**Re: 3800 Texas Drive
New Orleans, LA
Project Number: DR058-25
Our File #: 23-104**

CPC Design Advisory Committee Provisos [10.15.2025] - Response for DR058-25 (3800 Texas Drive)

New Apartments Building

3800 Texas Dr, New Orleans, LA
70114

LANDSCAPE PLANTING PLAN

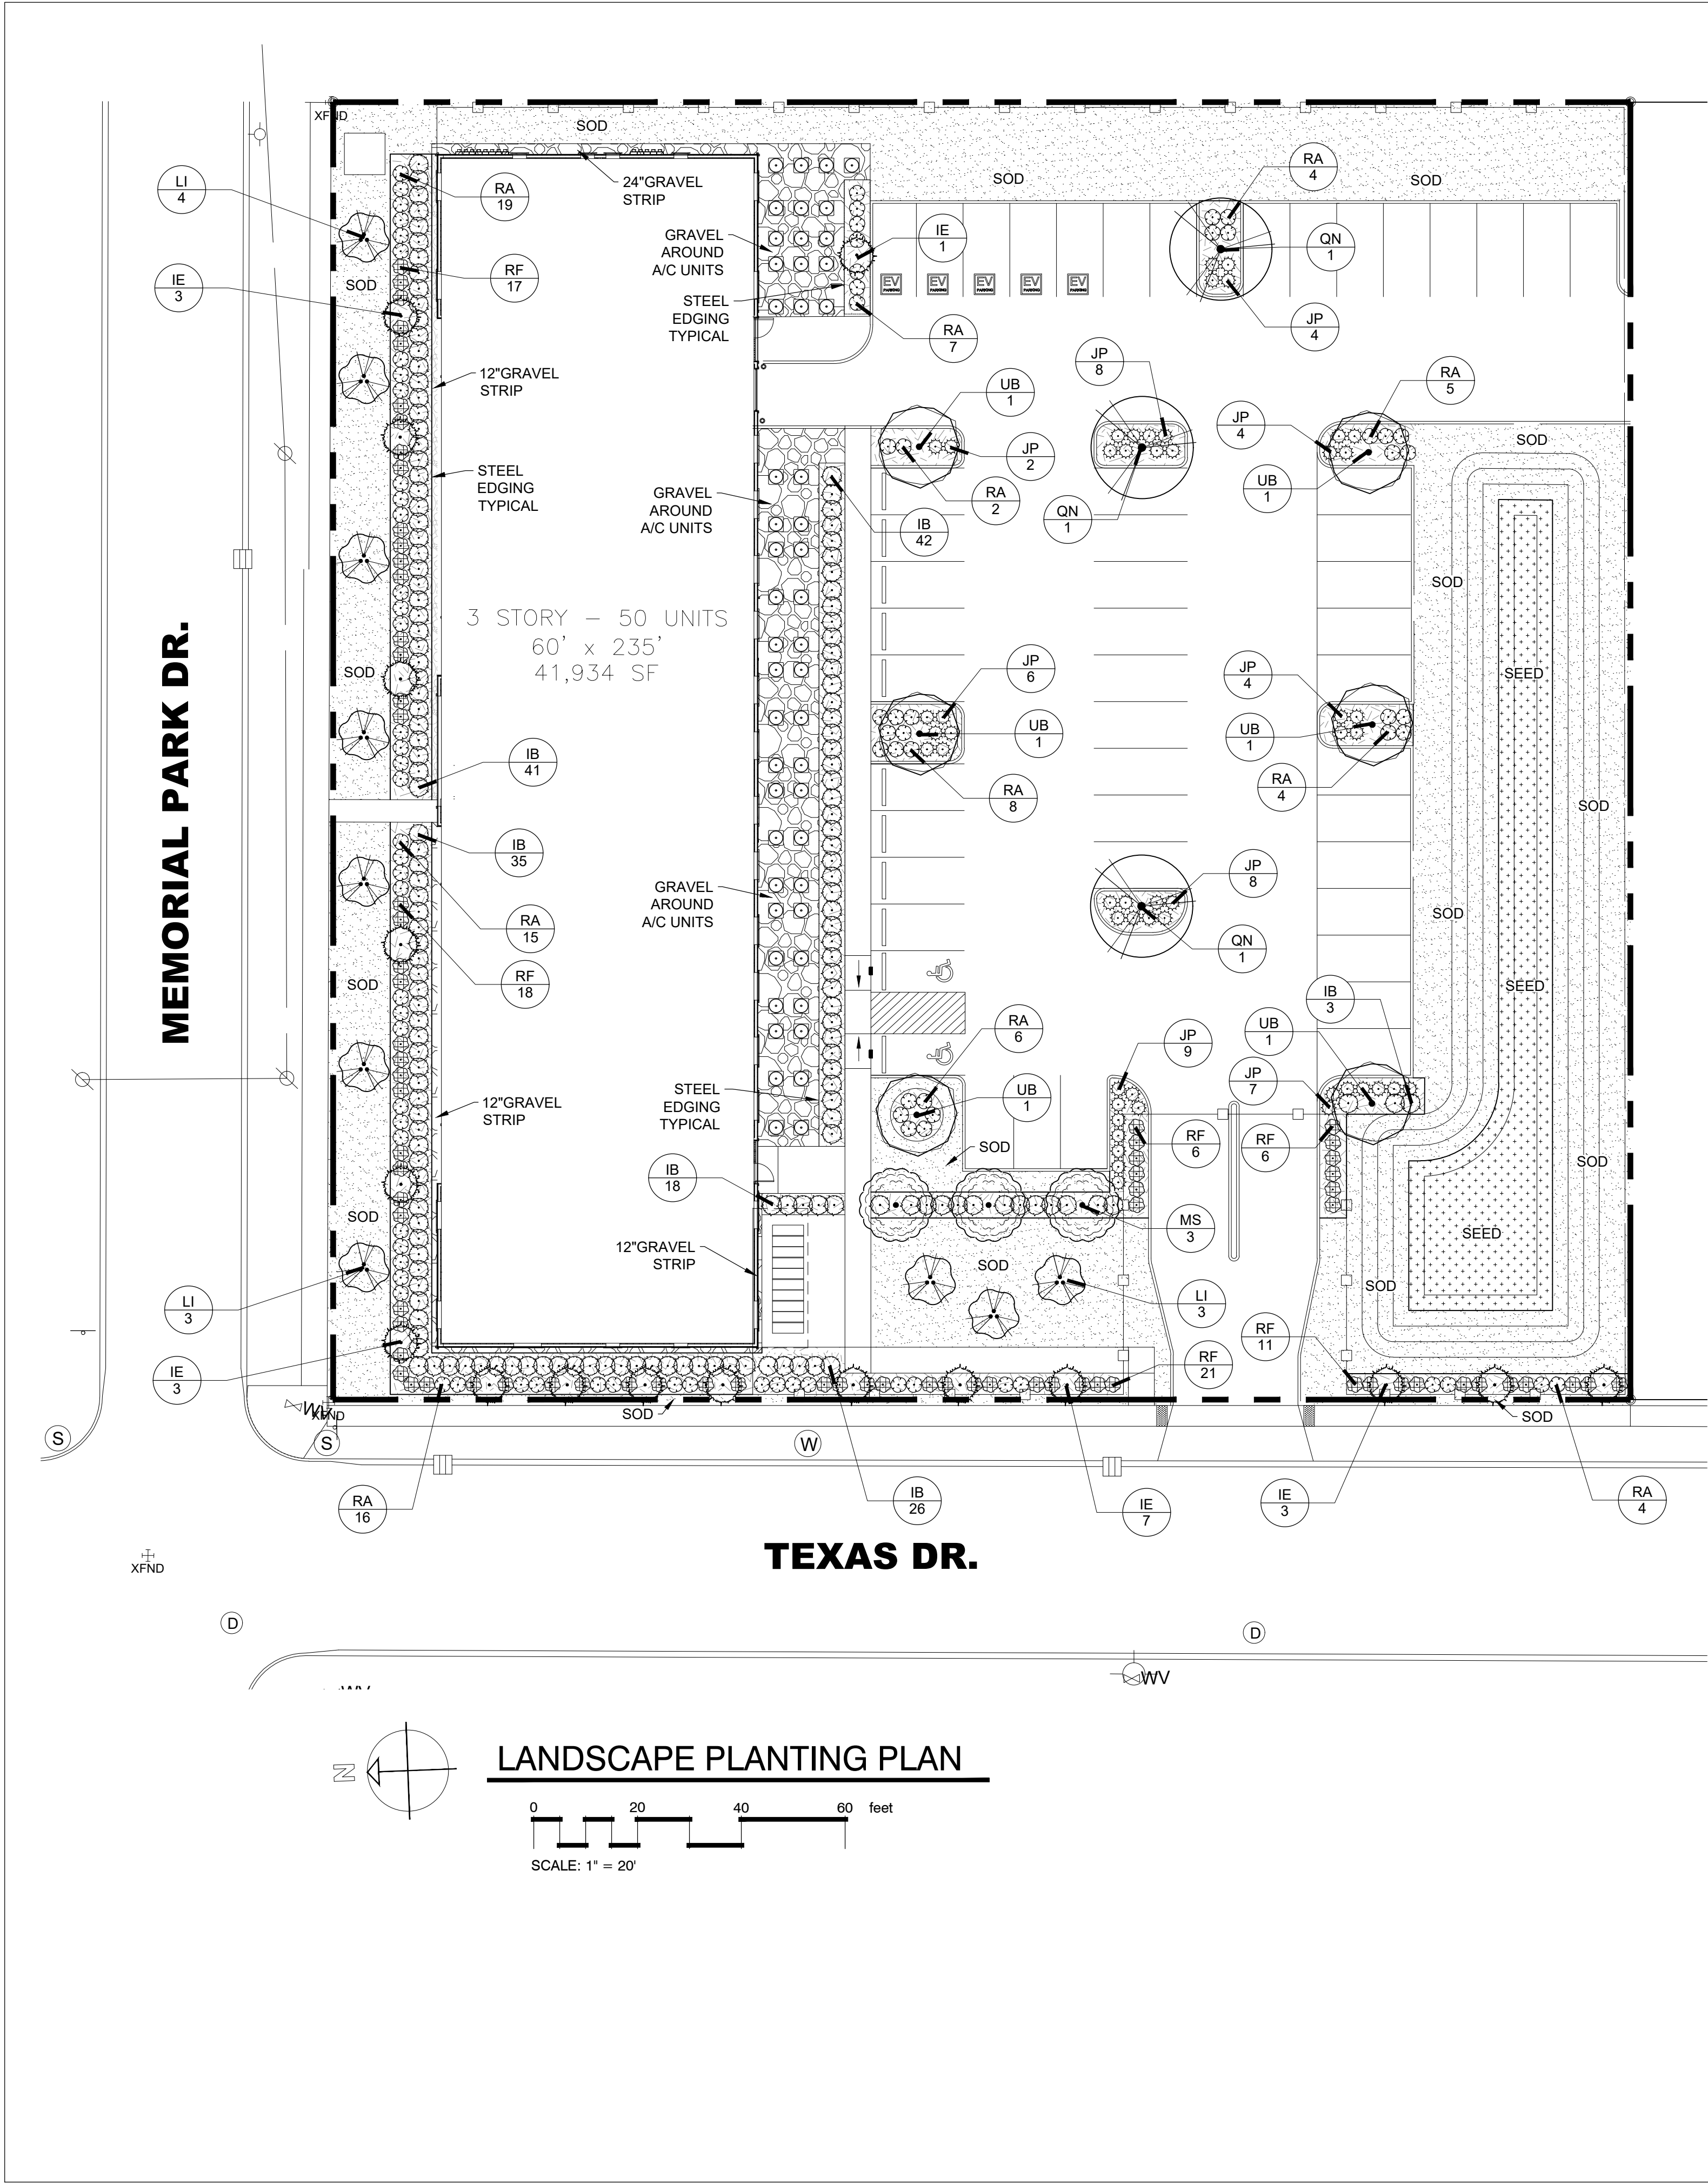
- 3A. Make the condenser units less visually obtrusive from within the site. And locate the condenser units so as to not block window openings on the ground floor.

- 3B. Provide landscaping in accordance with Article 23 landscaping requirements.

R:/ The location of the condenser units has been revised to be less visually obtrusive from within the site. The landscape plan (LS-1) illustrates the condenser units being screened by Dwarf Burford Holly (42), White Indian Hawthorn (7), and Eagleston Holly (1). The condenser units have been strategically placed to maintain the required mechanical clearances, and provide a clear sight line from the first floor window, bedrooms and as to not block window openings on the ground floor – please see revised layout on A101 – First Floor Plan and LS-1 Landscape

R:/ The landscaping is designed in accordance with Article 23 requirements, – please see revised SP-1 and sheets LS-1 and LS-2

② FENCE - ELEVATION, TYP.
3/4" = 1'-0"

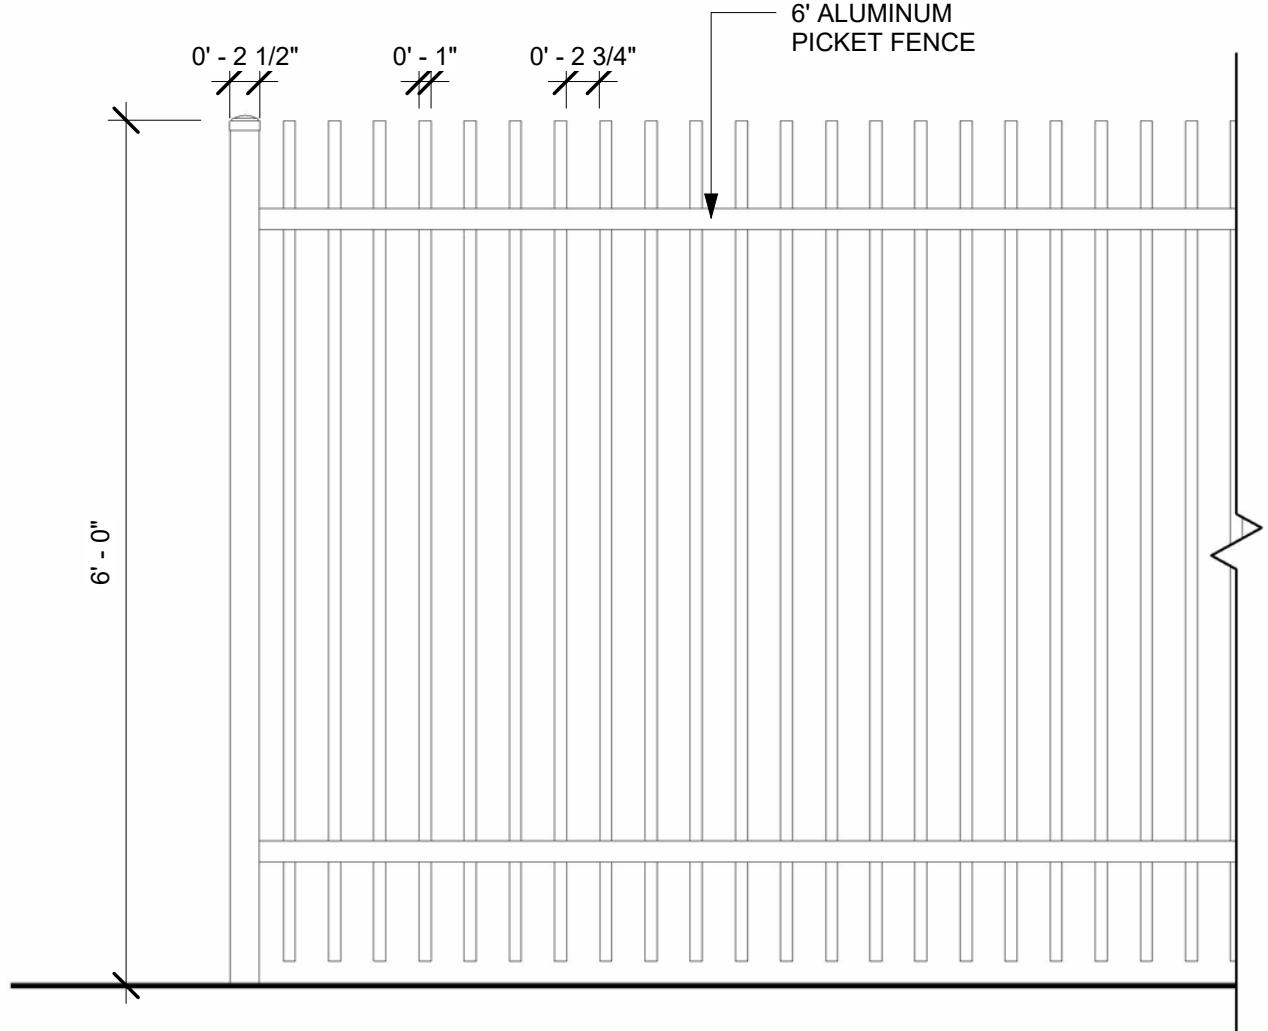
6. Re-design fence to appear welcoming to tenant and from the public perspective.

R:/ The fence will be similar in nature to the ones surrounding the proposal's site – the proposed aluminum picket fence will provide visibility for the pedestrian and residents as well as provide safety for the residents within the lot, and match the aesthetic of the surrounding lots – please see SP-1 and fence detail on sheet A052.

SHEET TITLE
FIRST FLOOR PLAN

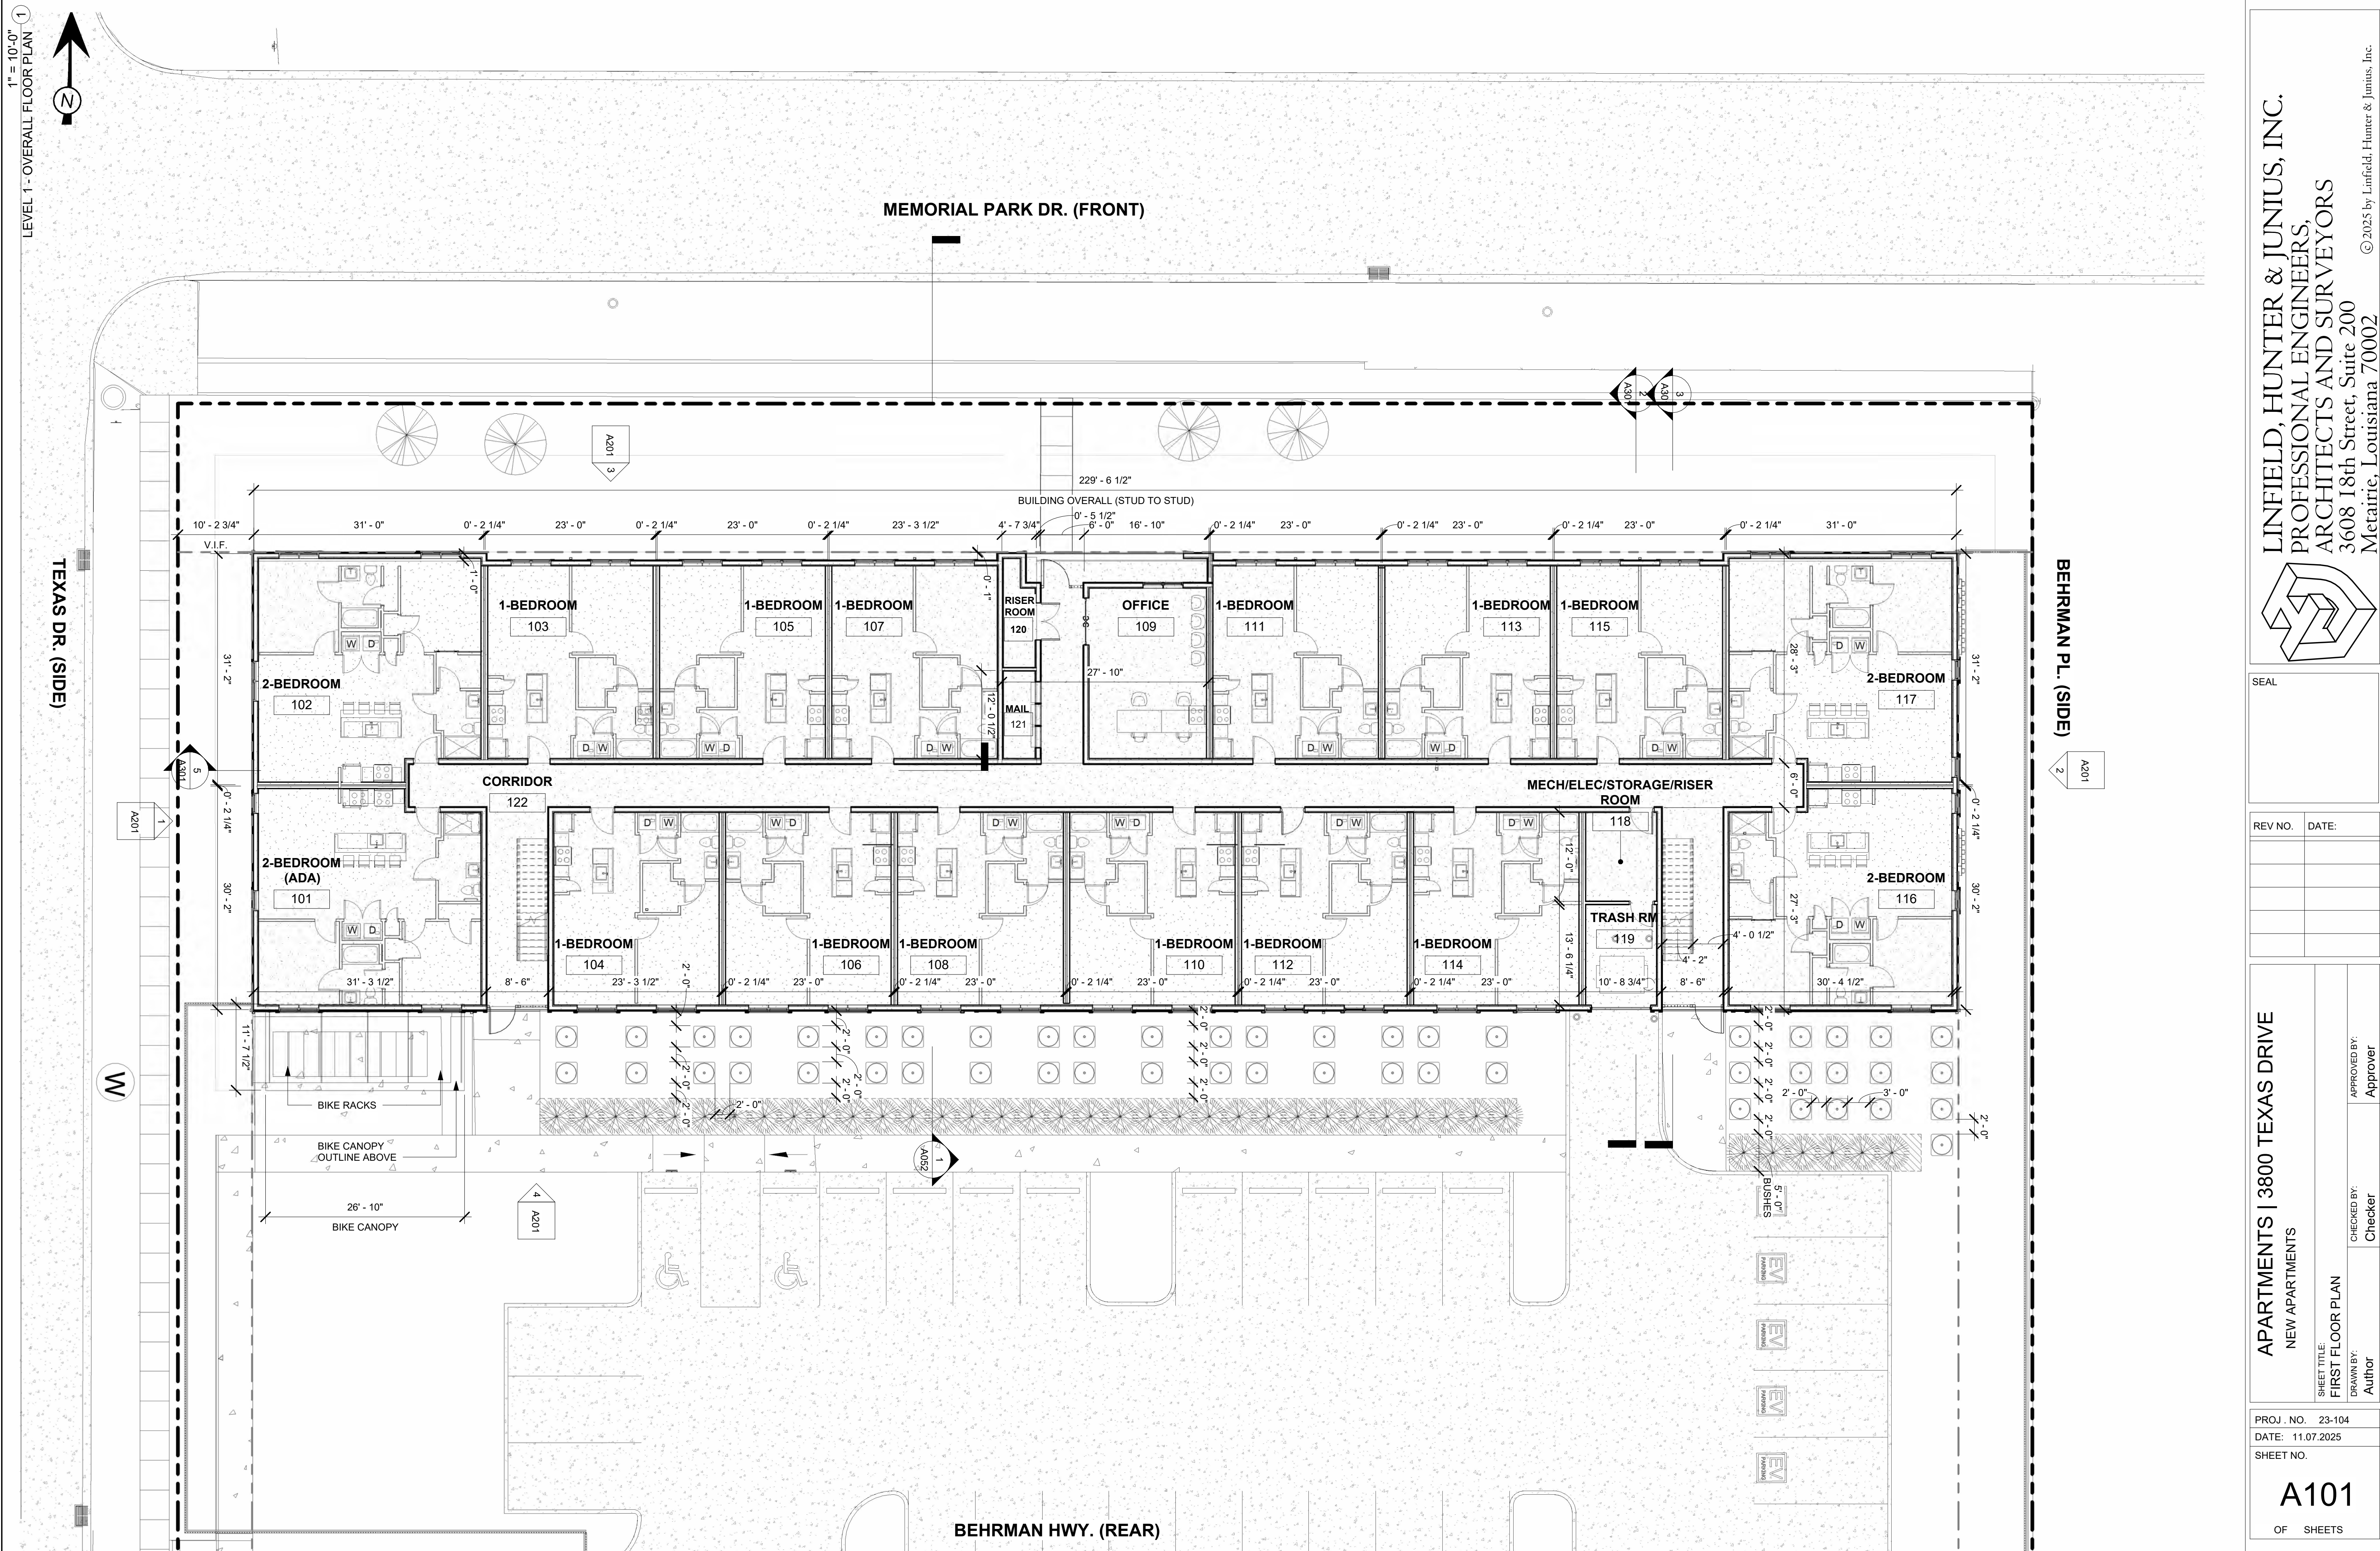
5. Provide visual interest and break down the massing of the front building façade through changes in plane, such as one-foot setbacks for portions, or include material changes to break up the façade.

R:/ The massing of the front building façade has been revised with one-foot setbacks and material changes throughout to provide visual interest and break up the façade – please see revised A101 – First Floor Plan and A201 – Building Elevations.
